MEMORANDUM

REVIEW TYPE: Preliminary Plan of Subdivision

PROJECT NAME: Holly Oak Property

CASE #: 120070180

Attachment B – Proposed Development Plan

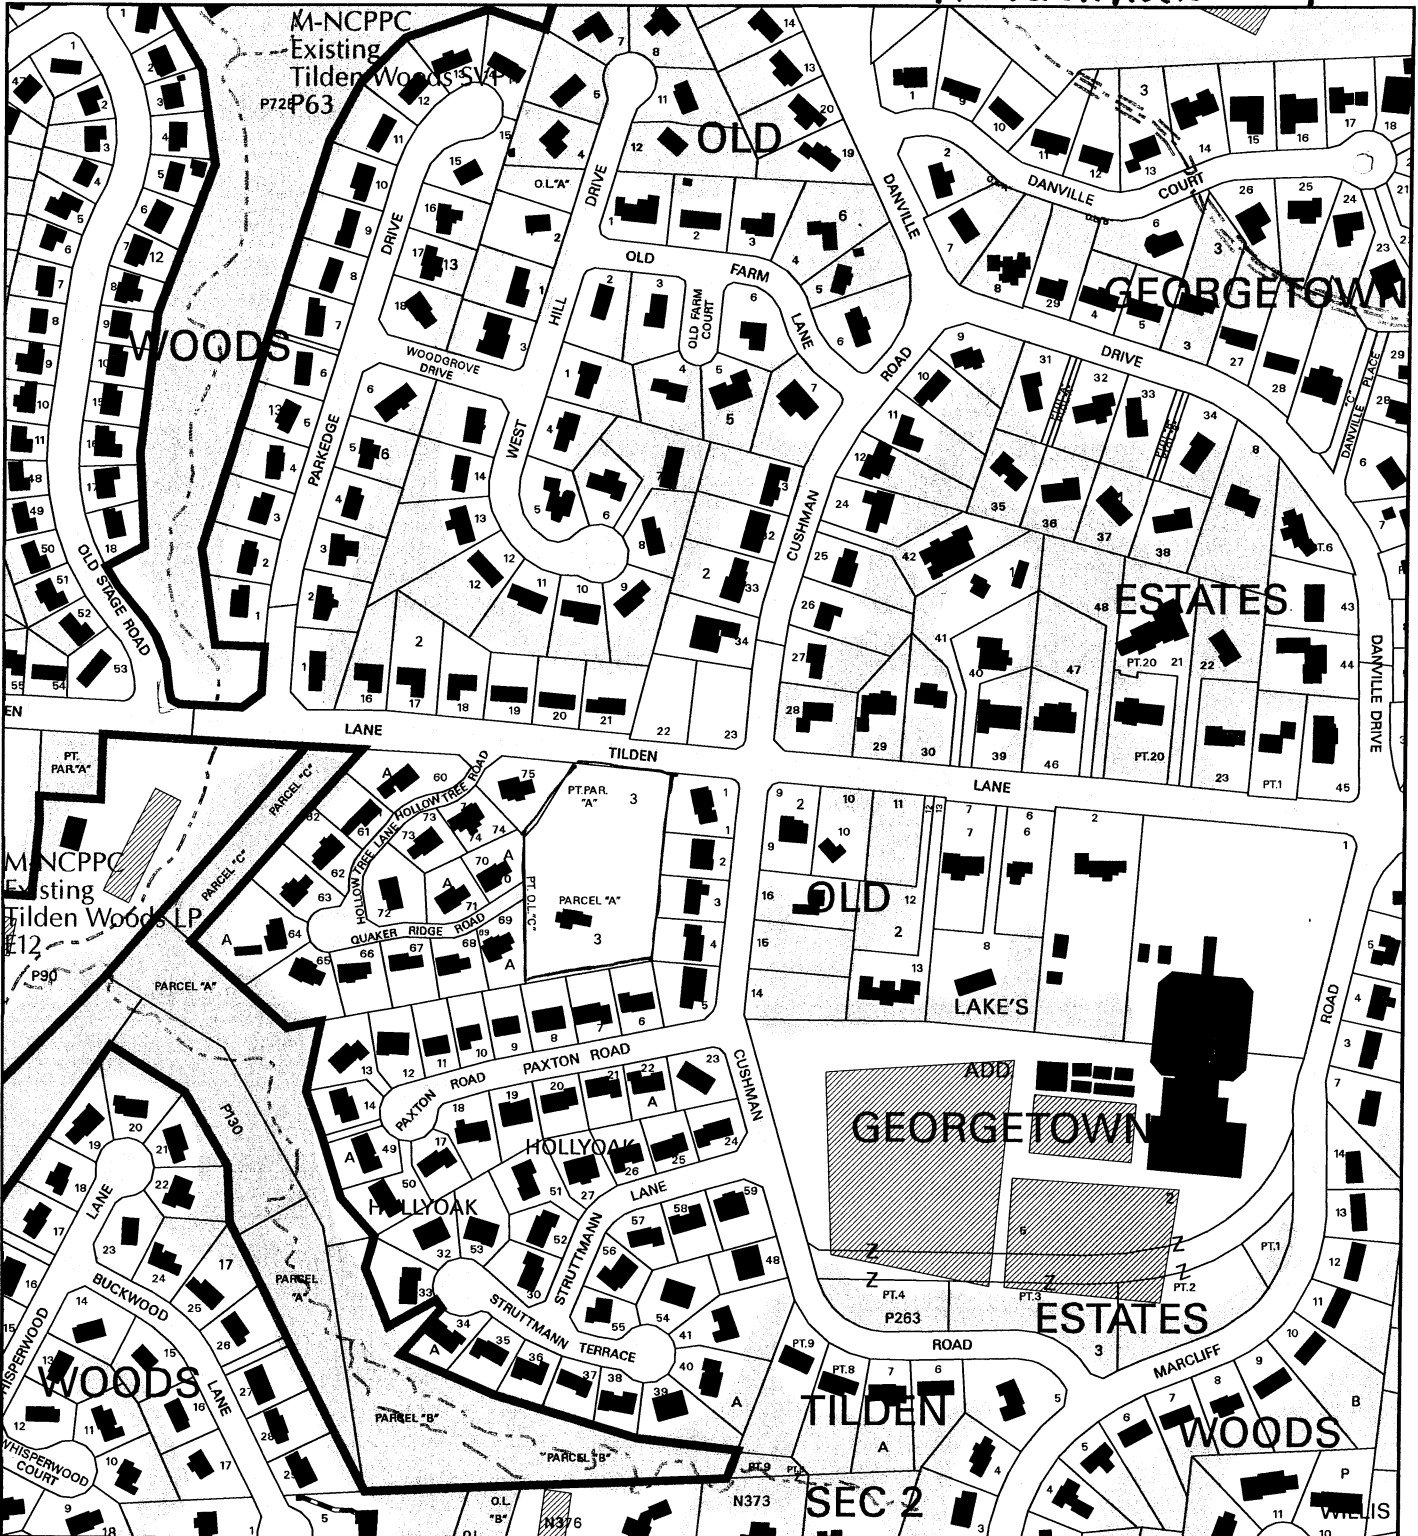
The plan does not show a sidewalk around the cul-de-sac bulb. Staff is not supporting a sidewalk for the cul-de-sac bulb for a number of reasons. First, existing Quaker Ridge Road has no sidewalk and MCDPWT has no current sidewalk project for this road. Further, it is

questionable as to whether there is adequate PIE width to accommodate a sidewalk on Quaker Ridge Road since it is shared with a 10 ft. PUE. The 10-foot PUE may currently include existing WSSC, Verizon, PEPCO, Comcast and Washington Gas utilities. It is doubtful that a sidewalk would even be allowed within the 10-foot space on top of these buried utilities. Since Quaker Ridge Road is a relatively low volume road, ending in a cul-de-sac, staff believes that pedestrians can safely use the cul-de-sac pavement in lieu of a sidewalk. For these reasons, staff does not support a sidewalk around the cul-de-sac bulb within the proposed subdivision but recommends that an adequate PIE/PUE be shown on the plat to accommodate one in the future, should there be a decision by Montgomery County to build one. Proposed vehicle and pedestrian access for the subdivision will be safe and adequate with the public improvements proposed by this plan

For this application, a reduced width tertiary street is the appropriate street cross section for the Planning Board to approve. Existing Quaker Ridge Road is built to reduced width tertiary street standards with 26 feet of pavement and a total right-of-way width of 28 feet. This plan proposes a short extension of Quaker Ridge Road that will terminate in a cul-de-sac. From a design and engineering perspective it would not make sense to build a standard tertiary street because the pavement widths would not be the same, and waivers by DPWT would need to be approved. Continuation of the reduced width tertiary would create a seamless transition of pavement.

To comply with Section 50-26(h)(2), the Board must find that there are environmental benefits or improved compatibility with adjoining properties that can be achieved with the reduced right-of-way width. The reduction allows the units to be pulled up closer to the street, which allows a deeper rear yard. This has the effect of pulling the grading for the house on lot 4 further away from a 30-inch dbh walnut tree on the lot. This tree was mentioned in a letter from an adjacent property owner who asked that it not be removed. The use of the reduced right-of-way provides further protection of this tree, which supports the justification that there will be an environmental benefit attributed to its use. The deeper back yards are also more compatible with the established rear yards in the neighborhood. For these reasons, staff is of the opinion that use of a reduced width tertiary street is justified for environmental and compatibility reasons.

Show proposed water house connection locations for proposed Lots 1 & 2. It is not clear how lot 2 will be served with water.

I live at 6609 Paxton Road. My property backs up to the proposed HollyOak development #120070180. On the Plat there is an error in the rear yard of Lot #4. The Walnut tree located there is at least 60 feet tall, not the 30 feet stated on the plat.

That tree is actually a 30 inch diameter tree. That is the diameter of the trunk measured at breast height or about 3 to 4 feet above ground. Looking at the plan, it is likely that the tree can be saved. While staff cannot mandate that the tree be saved our Environmental Planning staff will suggest that all reasonable efforts be made to protect it. Thanks for expressing interest in the development process.
